BIDDING AND CONTRACT REQUIREMENTS
ADDENDUM NUMBER 2

Architect's Project Number:
224151.00

Re: **Addendum Number 2 to the bidding documents for:
Moline – Coal Valley School District #40
Browning Field Concessions and Toilet Room Improvements**

ELECTRICAL FIRST
FLOOR POWER PLAN

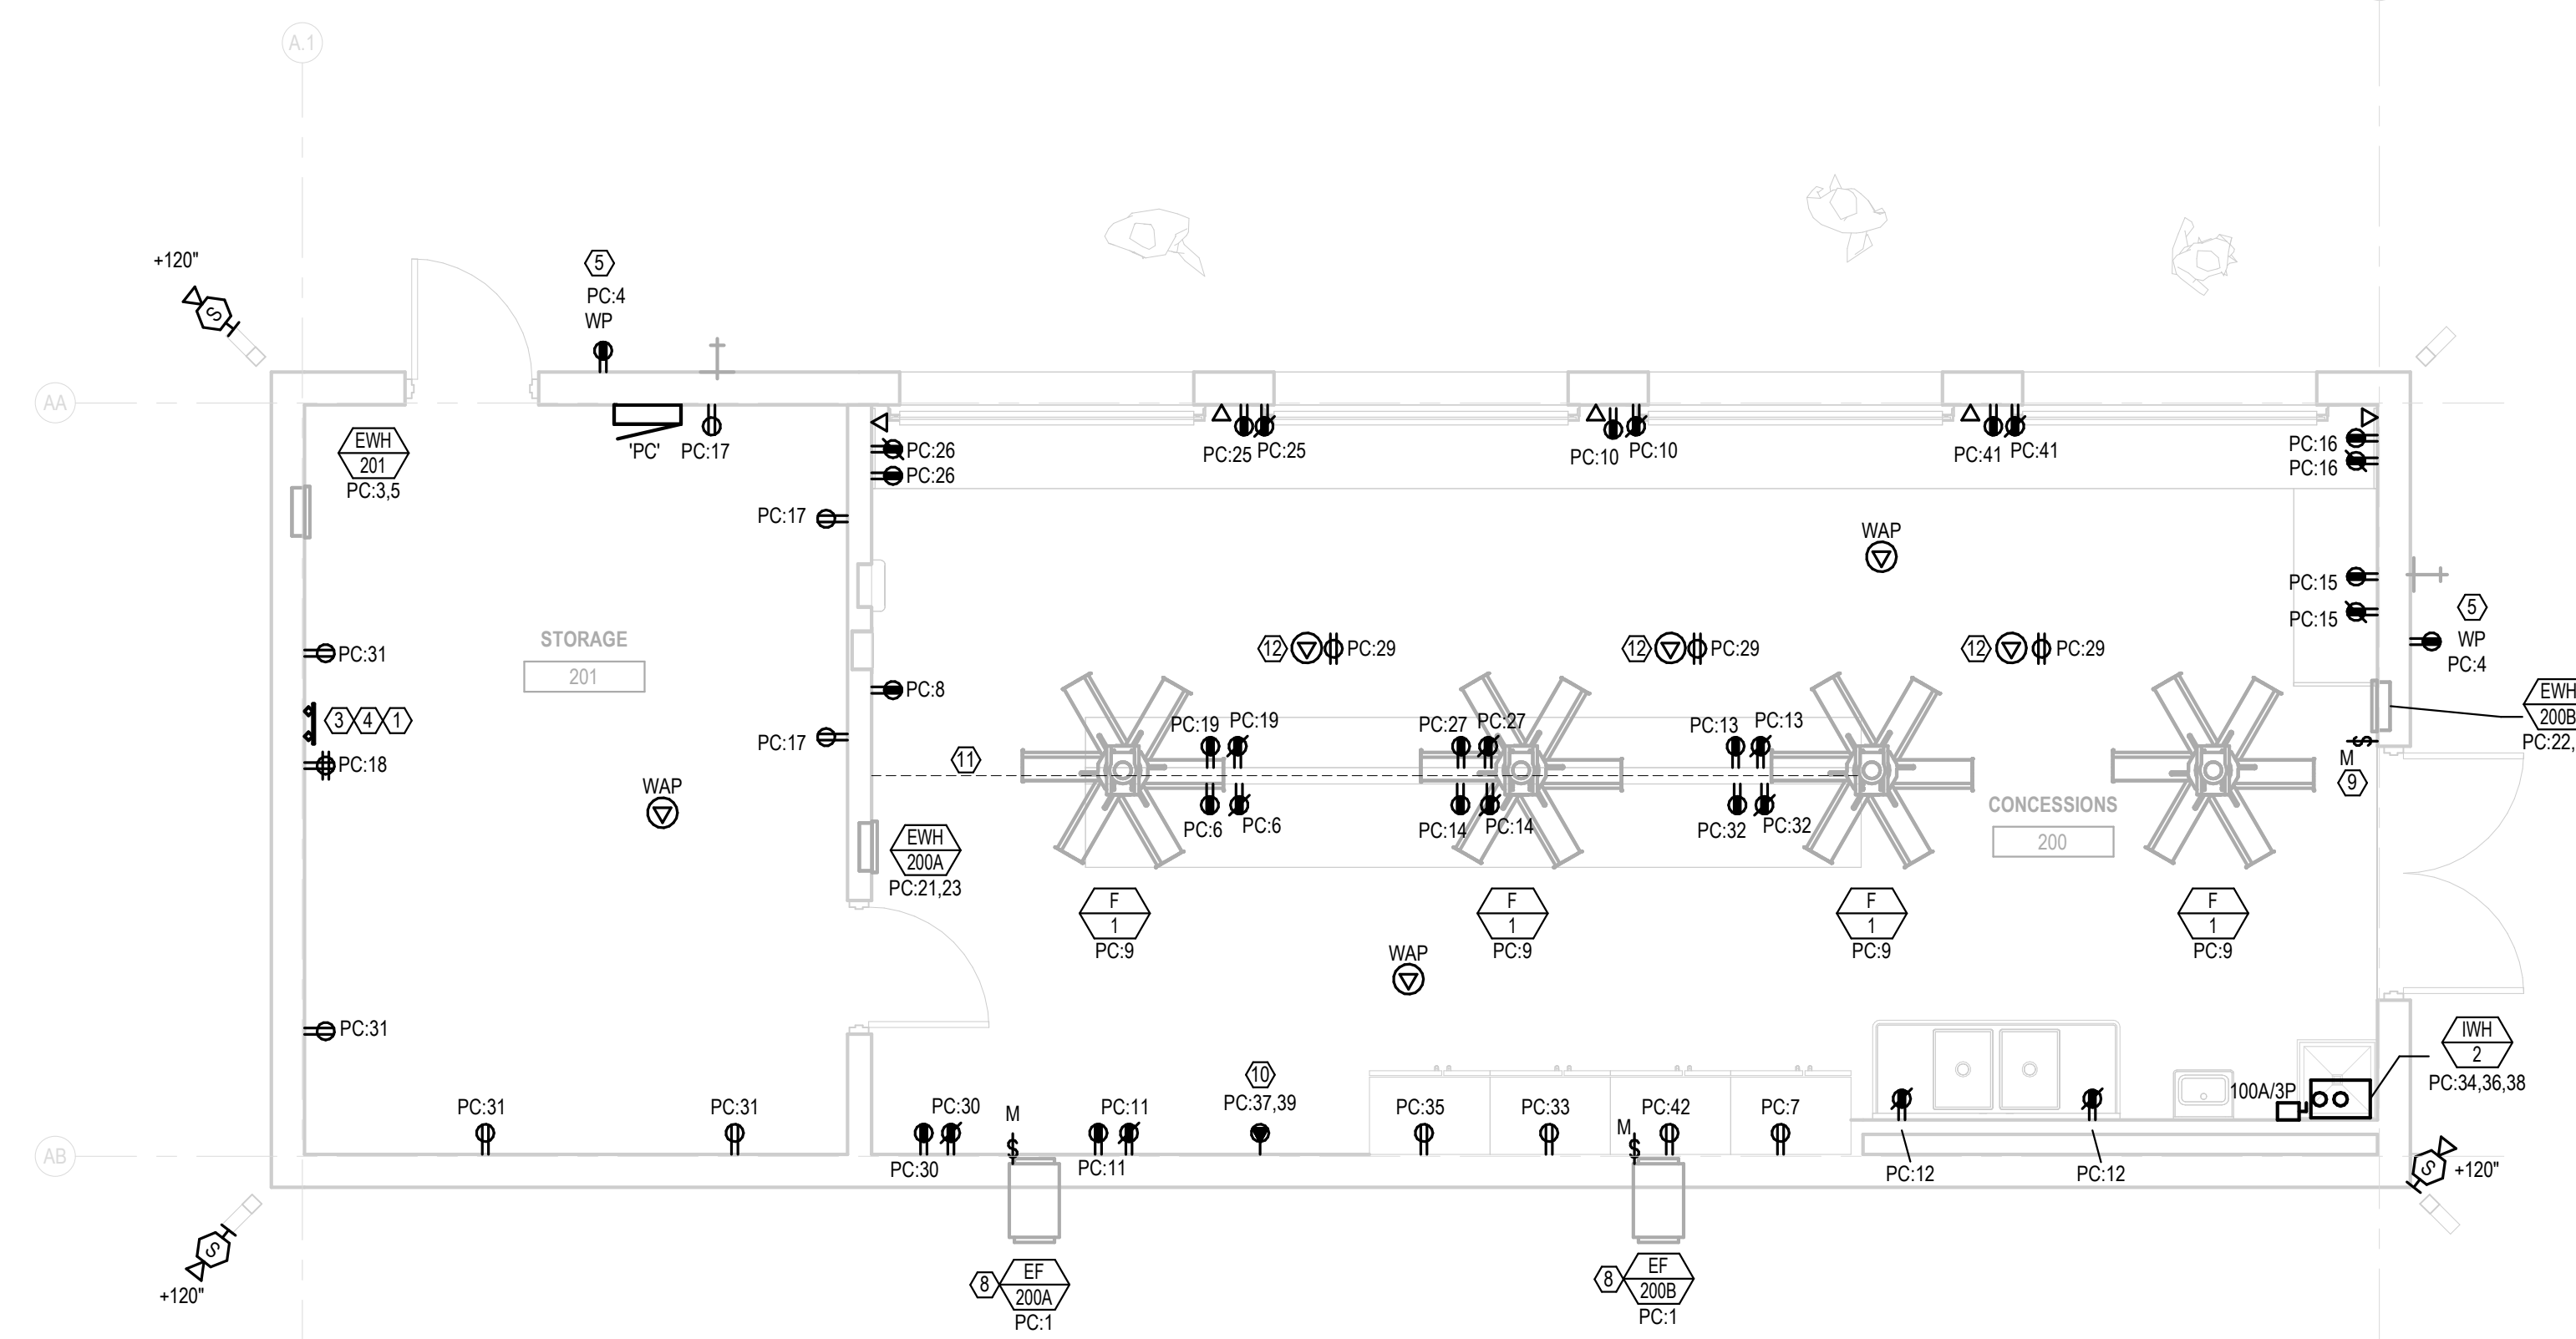
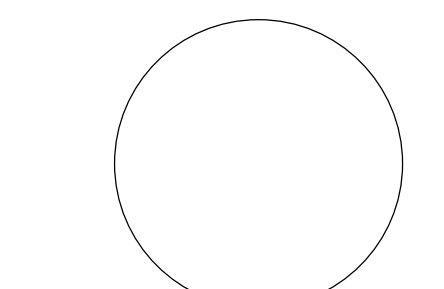
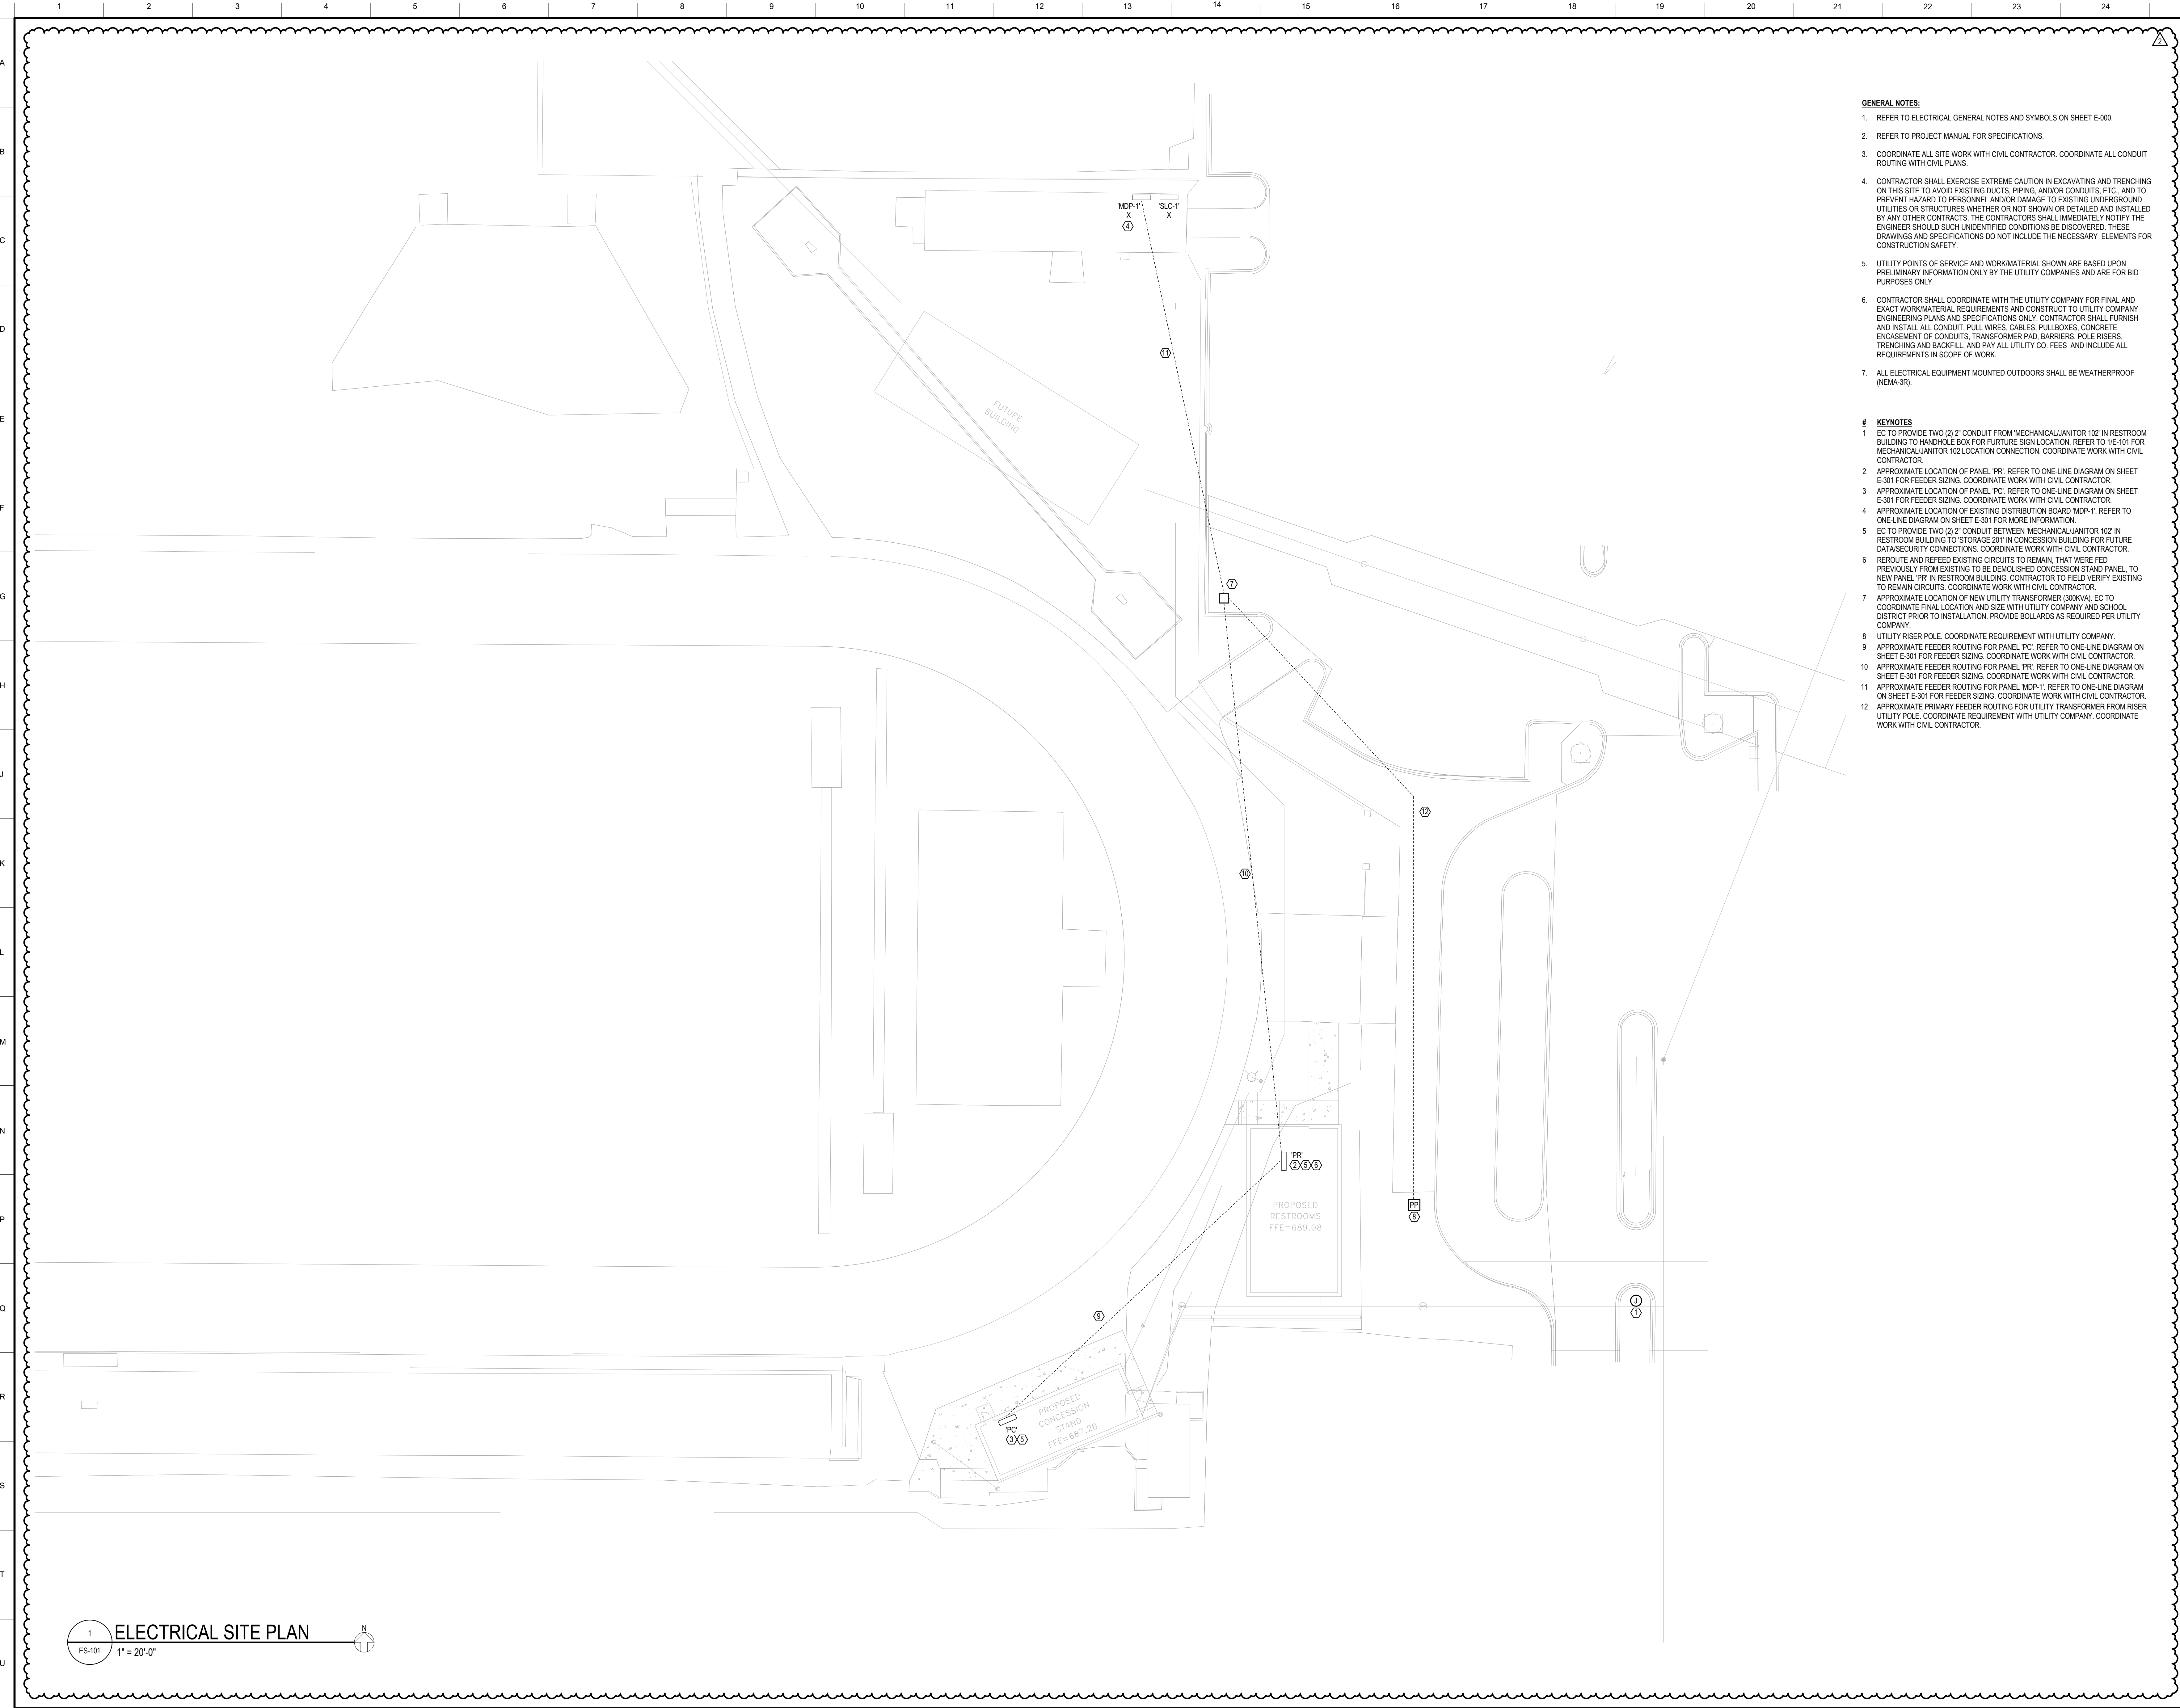
I. Drawing E-101, titled, **ELECTRICAL FIRST FLOOR POWER PLAN**

1. **REMOVE** Electrical meter with corresponding keynote at restroom building
